COA FIRE & EMS STATION - DAVENPORT VILLAGE

**4601 WESTLAKE DR
SP-2021-0121D**

VARIANCE REQUESTS

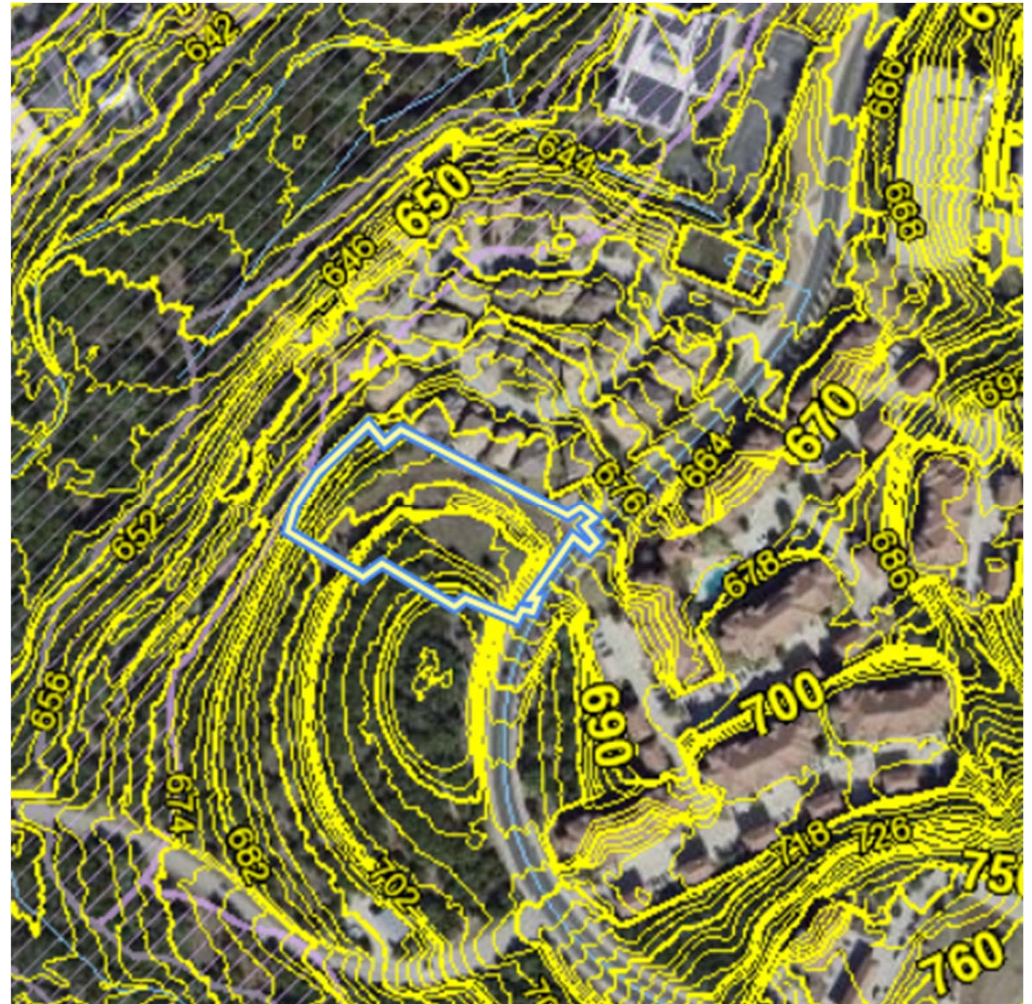
1. The variance request is to allow cut over 4 feet to 17 feet.

VARIANCE REQUEST

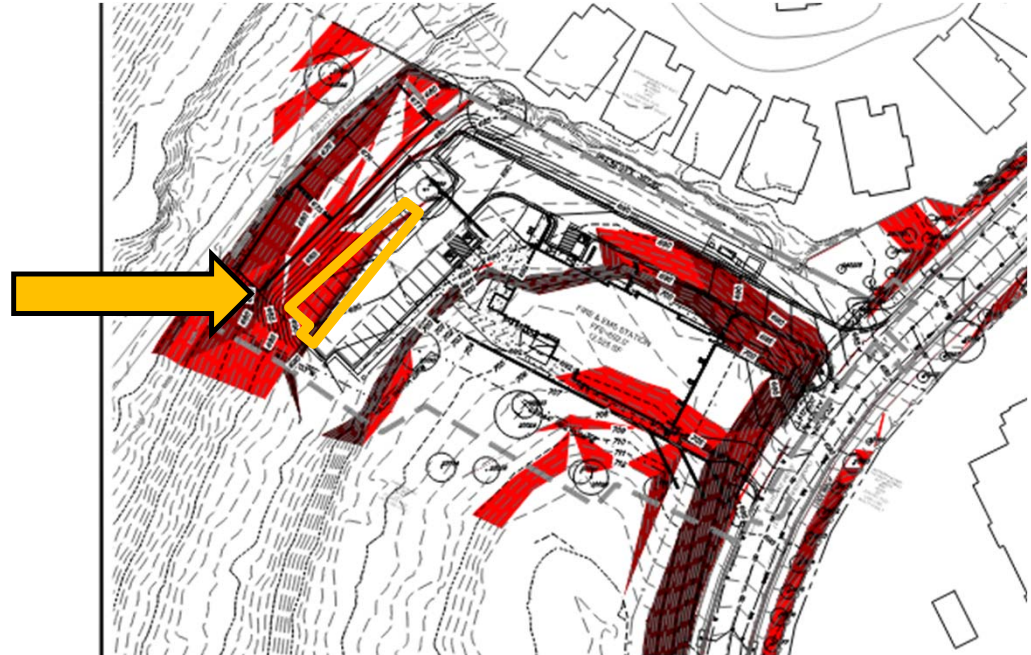
2. Vary Land Development Code 25-8-302 to allow a parking area on a slope with a gradient of more than 15 percent.

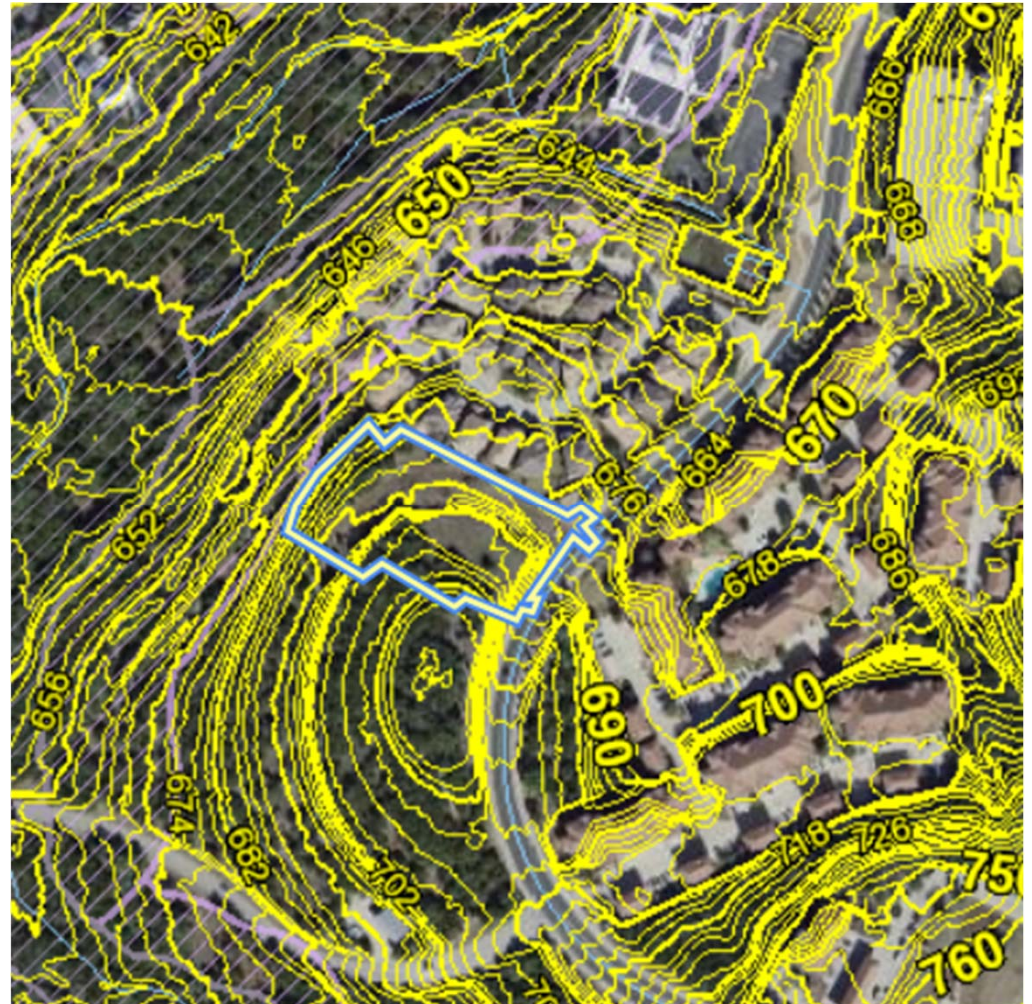
Staff recommends both variances, having determined that the findings of fact required by Land Development Code section 25-8-41 have been met.

Applicant will provide landscape plan, including mitigation for removed trees, to provide enhanced soil stabilization and water quality for the site.
